ORDINARY COUNCIL MEETING

Wednesday, 29 July 2020
Commencing at 5.00pm

Roadhouse Development Application
Lot 603 (No. 96) Martin-Pelusey Road, Picton East

SHEET
PLAN
SITE
PROPOSED

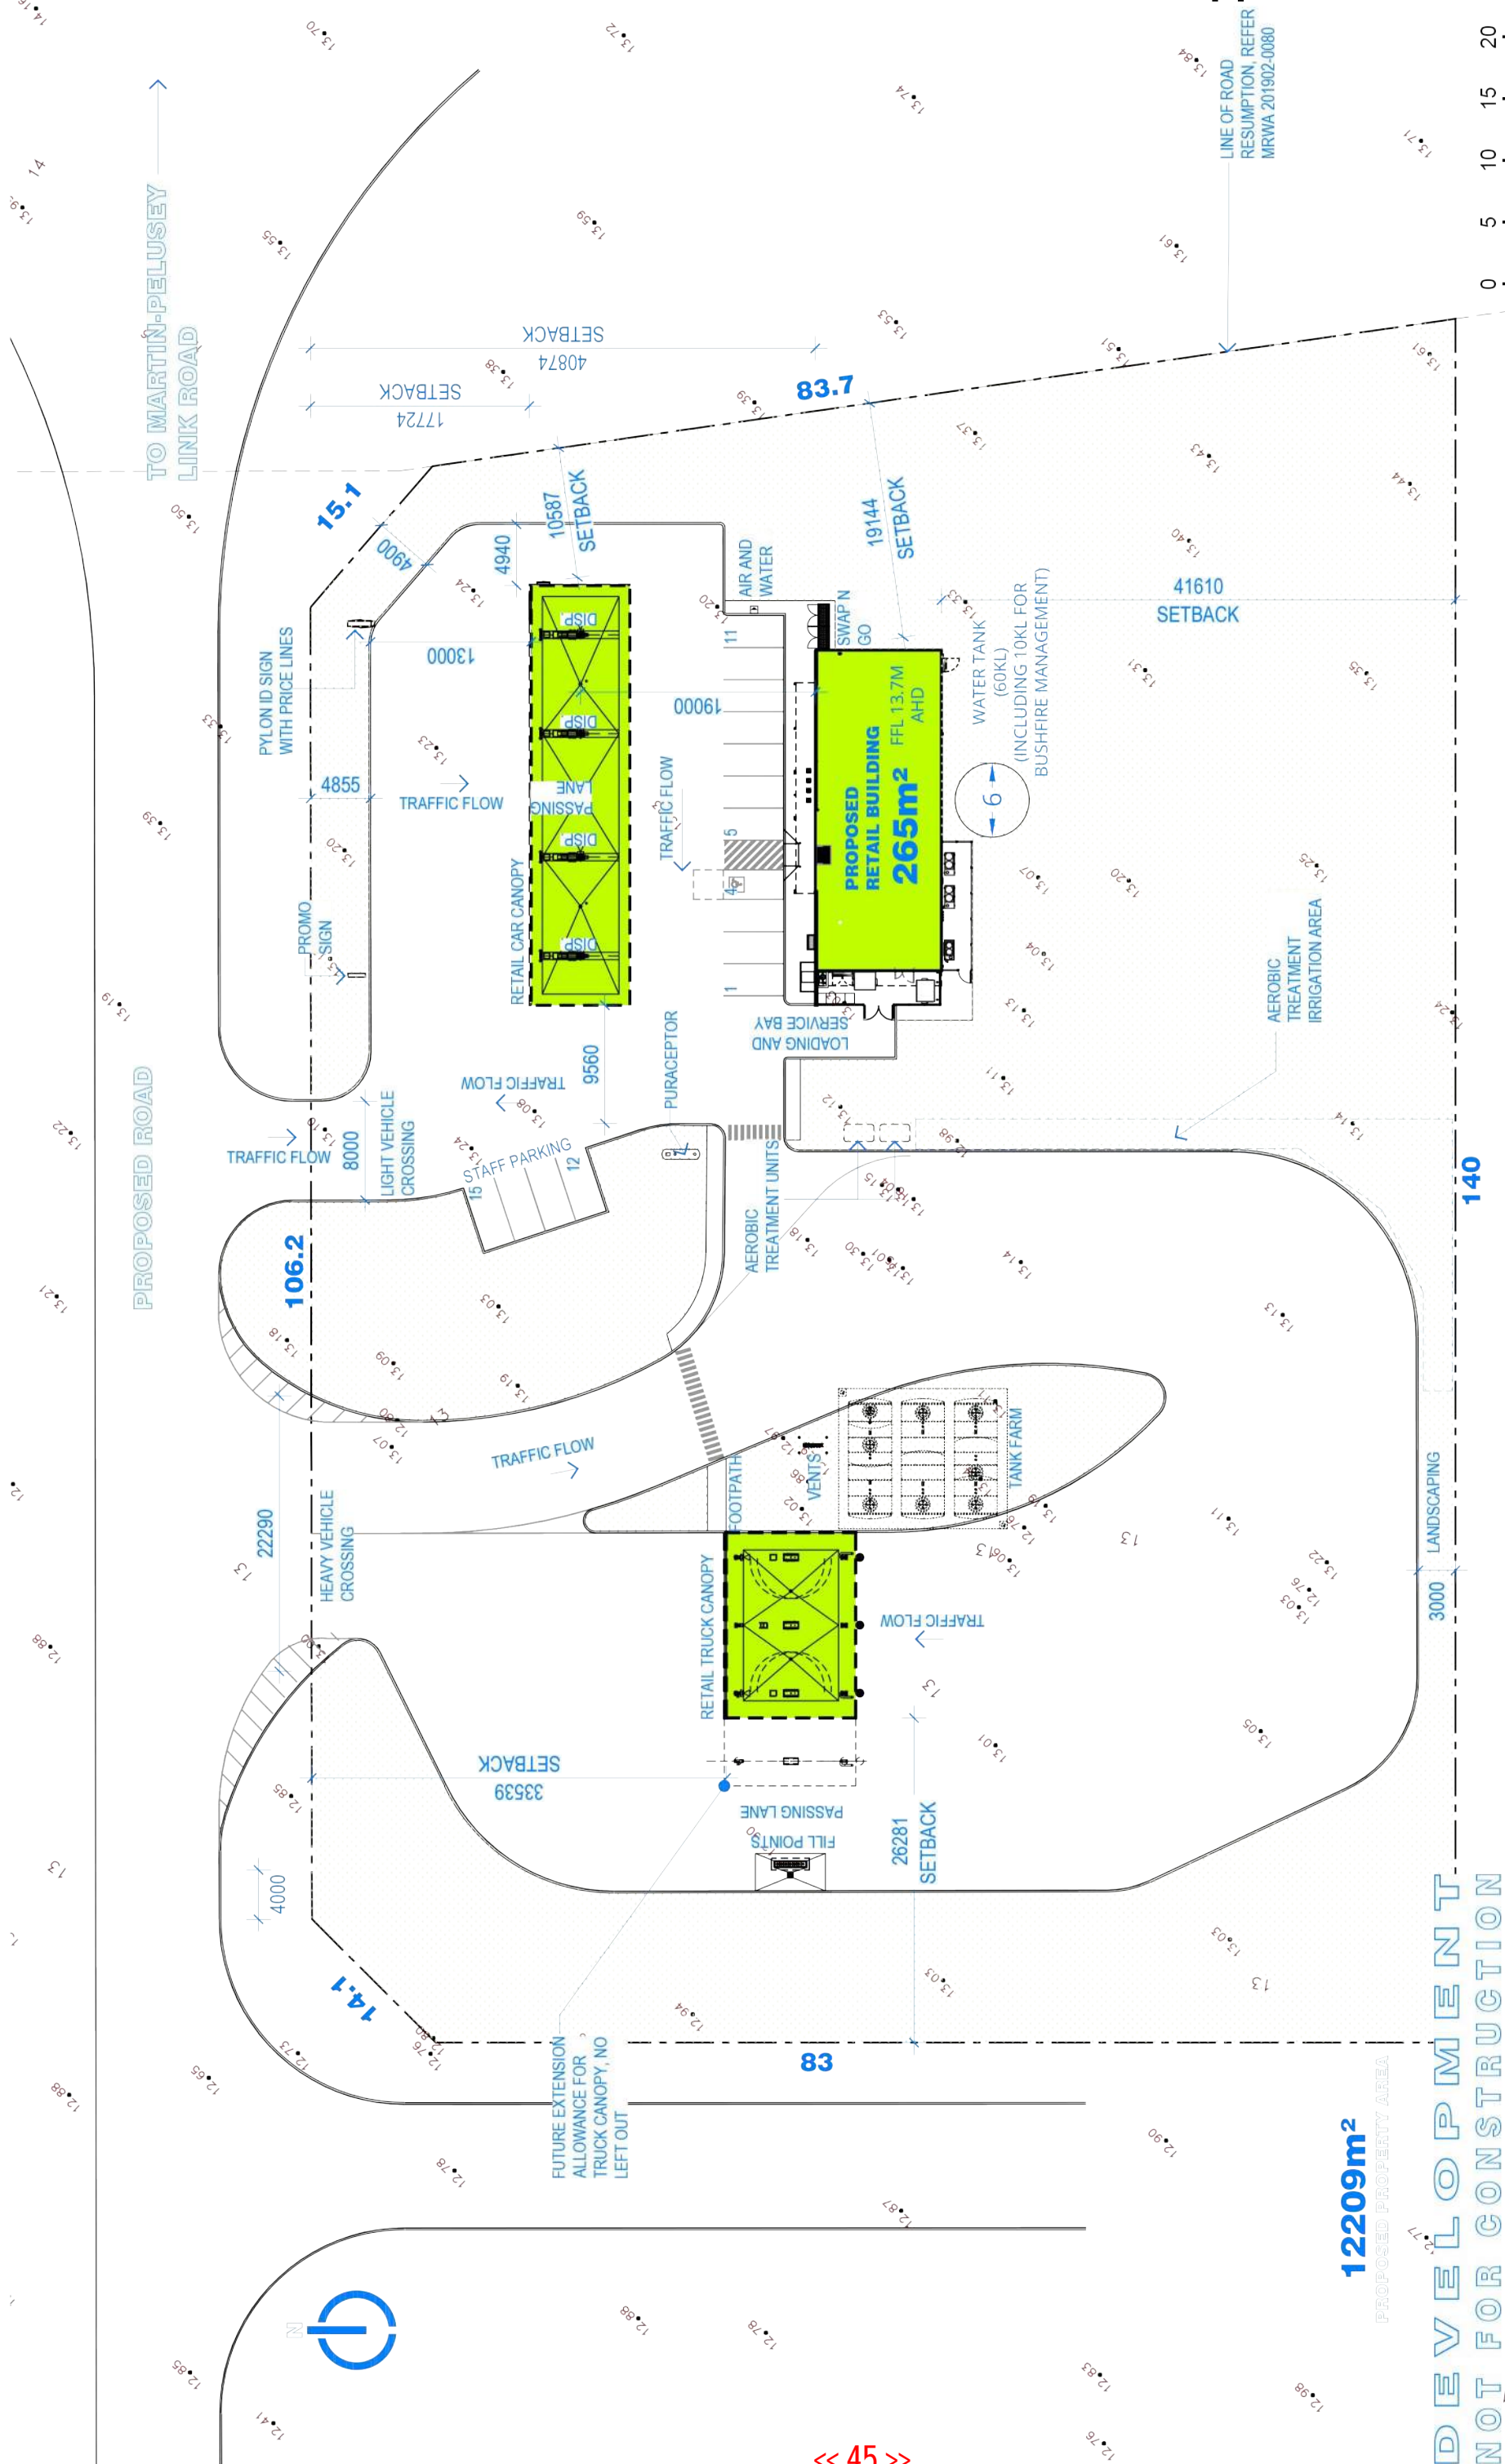
It is noted access is proposed to be taken from a future road identified as an 'Integrator' road in the strategic planning framework for the locality which will provide primary access to the future industrial area. Multiple, and over-width crossovers in the manner proposed has the potential to create significant traffic conflict and safety issues as they present an uncontrolled form of access and egress to a road, particularly in relation to vehicle sight lines and 'masking' of through traffic. It is recommended that the crossover widths be reduced to address these aspects. There appears to be potential for the fuelling points be set back further and the width of the egress way/ crossover be reduced accordingly. To avoid conflict with future road investigations/requirements it is recommended that the proposed development be relocated outside to the existing Primary regional road reserve as a minimum.

REV.	DESCRIPTION
A	Development Application
B	Carriageway increased to 10m, truck crossing and canopy moved east 4m
C	Truck canopy relocated, swept paths and kerbs revised to suit.

- The comments regarding the multiple and over-width crossovers, however, are valid, and the proposed Development Application site plan has been revised to take these comments into account. The revised plan is therefore shown in the attached Figure 4, together with an overlay of the proposed roundabout at Martin Pelusey Road.

FIG. 1

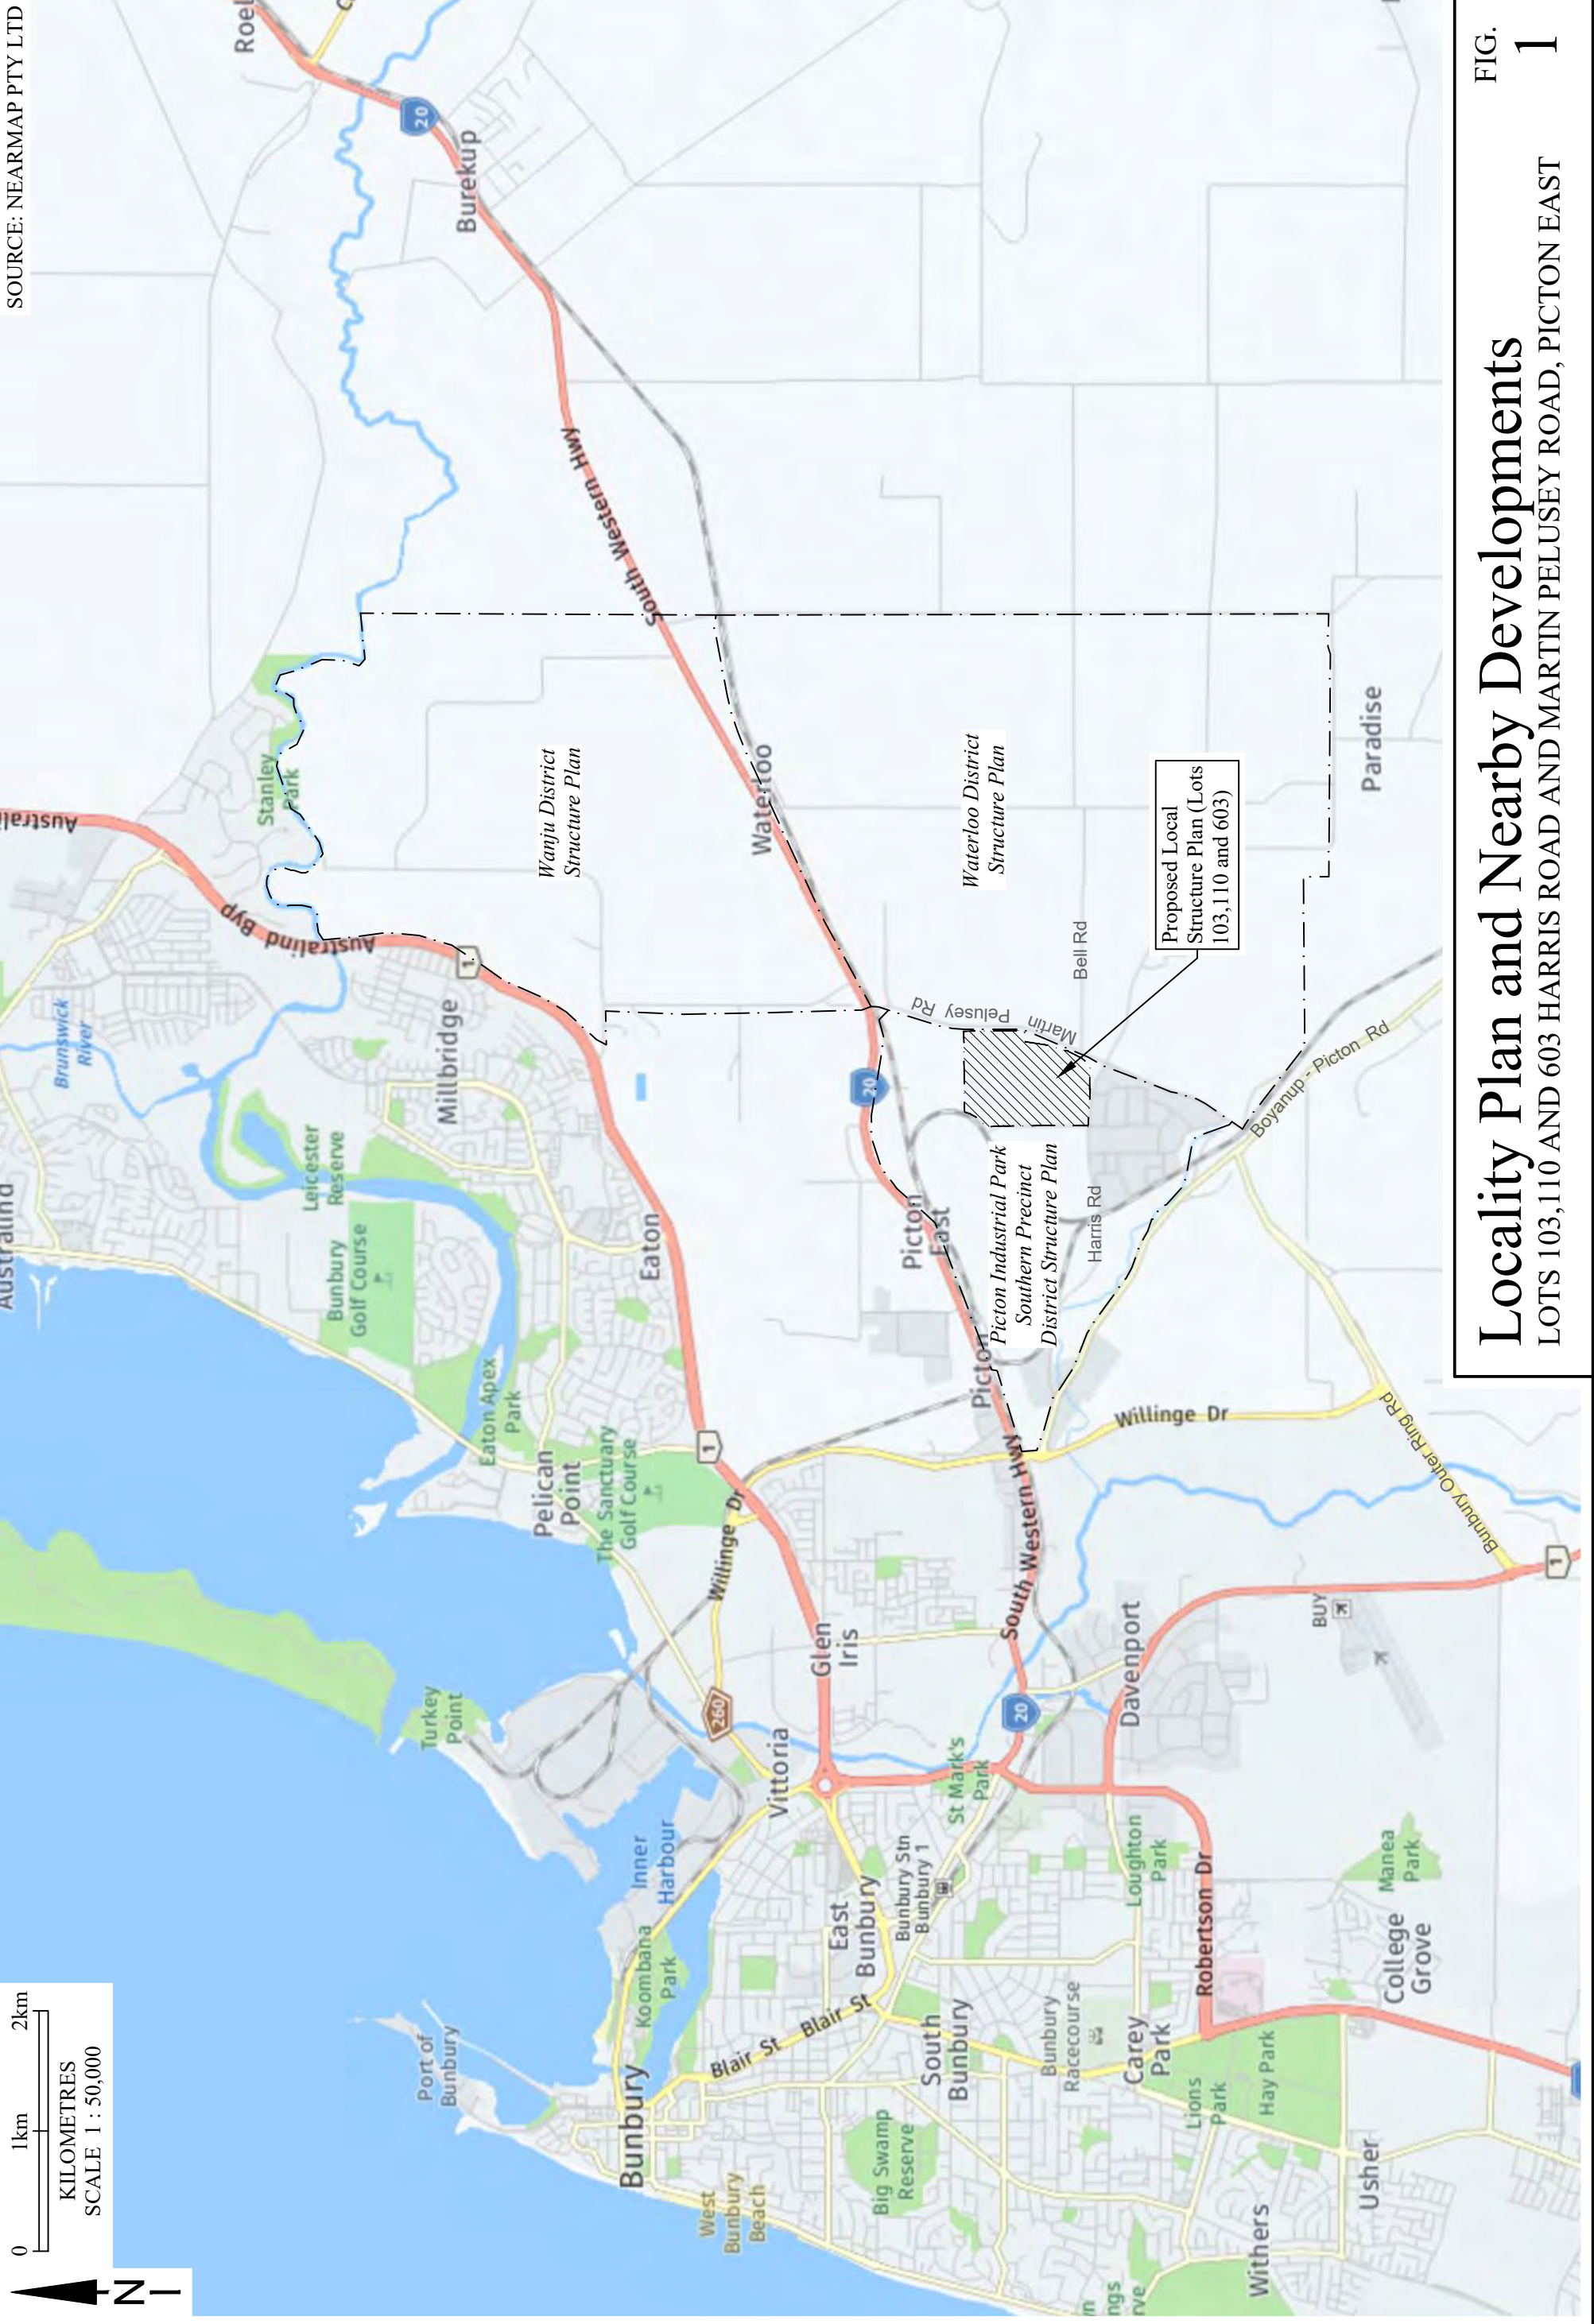
- If, as suggested by Main Roads WA, there is a requirement for a Primary Regional Road reservation to be included for the future overpass at South Western Highway, the attached Figure 1 (updated from Figure 2 in our November 2019 Transport Assessment Report) shows how this could be incorporated into the 2 District Structure Plans, with no impact at all on the proposed Development Application (or Local Structure Plan) at Lot 603.
